# UNITED STATES PATENT AND TRADEMARK OFFICE

APPLICATION NO.	FILING DATE	FIRST NAMED INVENTOR	ATTORNEY DOCKET NO.	CONFIRMATION NO.
10/622,491	07/21/2003	Brian Roberts	10750-250	4988

## Office Action Summary

## DETAILED ACTION

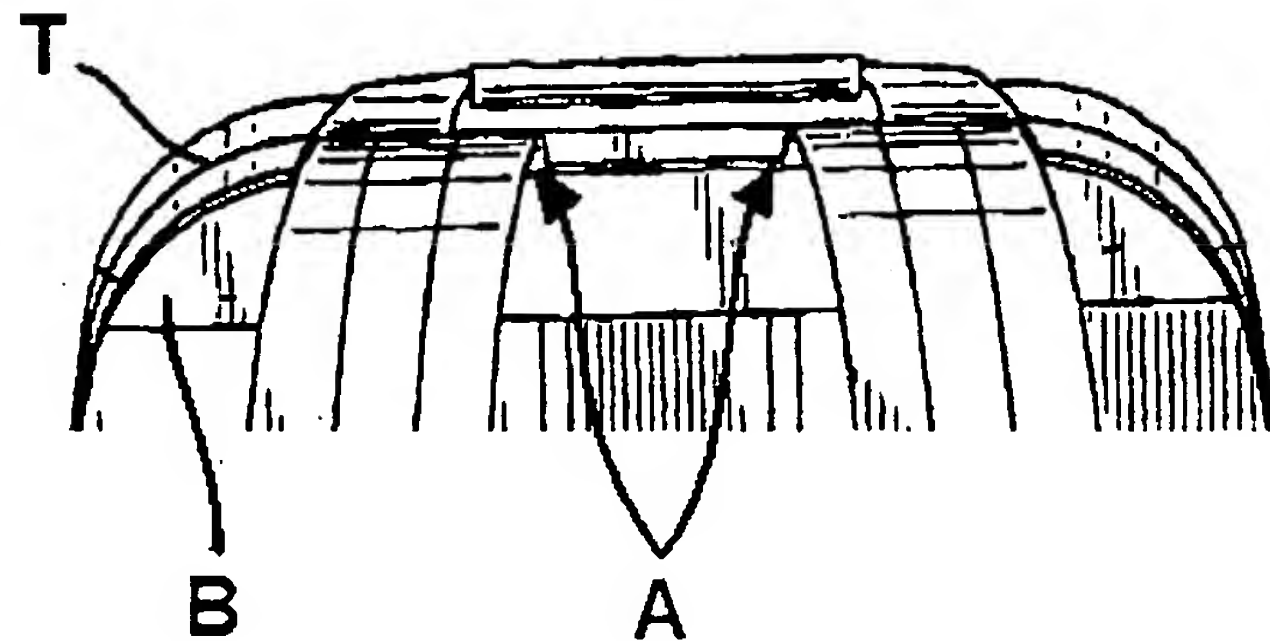
Regarding claims 38, 42, 44, 48, the back-facing face of the modified Ivarson et al. backpack has a top end (T, figure below) and the shoulder strap is connected to the back-facing face (B, figure below) at a position (A, below) spaced from the top end of the back-facing face.
